Project	IEEE 802.16 Mobile Broadband Wireless Access Working Group < http://ieee802.org/16 >
Title	Subnet Zone ID Support
Date Submitted	[2004-05-19]
Source(s)	Yong Chang Samsung Elec. Dongkie Lee, DongIl Moon, DongRyul Lee, JongKuk Ahn, Sungho Ha SK Telecom
Re:	Working Group Review of P802.16-REVe_D2
Abstract	If the MSS moves the subnet boundaries, then the MSS can trigger to request re-assignment of IP address or MIP refreshment by knowing the Subnet Zone ID transmitted in NBR-ADV and PAG-ADV.
Purpose	Propose to add new Subnet Zone ID in the text of IEEE802.16REVe/D2-2004
Notice	This document has been prepared to assist IEEE 802.16. It is offered as a basis for discussion and is not binding on the contributing individual(s) or organization(s). The material in this document is subject to change in form and content after further study. The contributor(s) reserve(s) the right to add, amend or withdraw material contained herein.

10 **Figure 1 BS Group ID Grouping example**

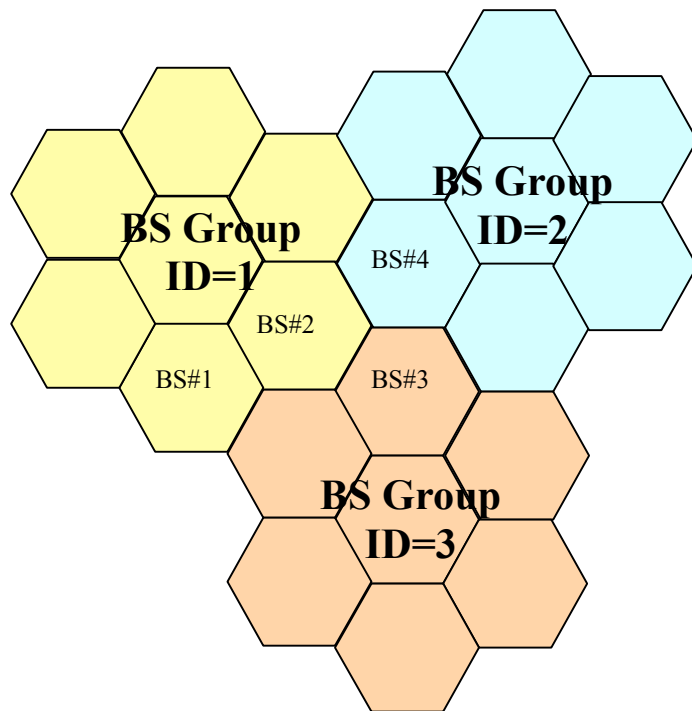
1 The BS's are divided into logical groups called BS Group which is in the same subnet for DHCP case
 2 and/or is managed by the same Foreign Agent. A BS belongs to one and only one BS Group ID. If the
 3 operators would like to separate the DHCP subnet zone and FA administration zone, two different BS
 4 Group IDs are required. But for simplicity of OA&M administration, it is better to have DHCP subnet
 5 zone and FA administration zone same.

11 With BS Group ID concept, Layer 2 handoff, which does not necessitate IP address change or FA
 12 address change, rather than Layer 3 handoff is realized in the same BS Group zone.
